# Access Compliance Report

## Public Rights-of-Way

### (Curb Ramps)

Intersection ID: 13292	Main Street: E_3RD_ST	Cross Street: S_MCDOWELL_ST	Location: S
ADA ID: 4D7287974944	Ramp Type: PerpDiag	Initial Pass/Fail: Pass	Overall Compliance: No
Severity Score: 0.25			
Codes/Mitigation Info/Possible Solution		Field Measurements/Component Compliance

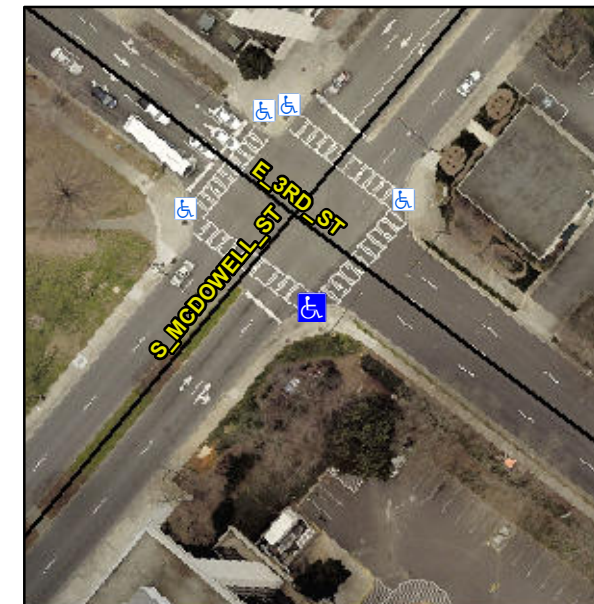
**Not Found, R304.5.3, R305.2**

Compliance	Description	Data	Compliance	Description	Data
N/A	Ramp Length (in)	80.0	Yes	Ramp Slope (%)	5.7
Yes	Ramp Width (in)	48.0	No	Ramp XSlope (%)	4.1
N/A	Flare Type LT	Sloped	N/A	Flare Type RT	N/A
N/A	Flare Slope LT (%)	2.7	Yes	Flare Slope RT (%)	1.5
N/A	Flare Traversable LT?	Yes	N/A	Flare Traversable RT?	Yes
Yes	Landing Length (in)	73.0	Yes	DWS Provided?	Yes
Yes	Landing Width (in)	48.8	Yes	DWS Contrast?	Yes
Yes	Landing Slope (%)	1.0	Yes	DWS Length (in)	24.5
Yes	Landing X Slope (%)	0.3	Yes	DWS Full Width?	Yes
N/A	Landing Curb? (Y/N)	No	No	DWS Offset (in)	3.5
N/A	Shared Landing?	No			
Yes	Gutter Ponding?	No	Yes	Gutter Slope (%)	1.2
Yes	Gutter Lip Ht (in)	0.0	Yes	Gutter X Slope (%)	0.4
N/A	Painted X Walk1?	Yes	N/A	Painted X Walk2?	Yes
	X Walk 1 Direction	To NE		X Walk 2 Direction	To NW
N/A	X Walk 1 Width (in)	118.0	N/A	X Walk 2 Width (in)	118.0
	X Walk 1 Slope (%)	1.1		X Walk 2 Slope (%)	1.8
	X Walk 1 X Slope (%)	1.3		X Walk 2 X Slope (%)	2.7

**Remove & Replace Curb Ramp With Two New Directional Ramps or Equivalent.**
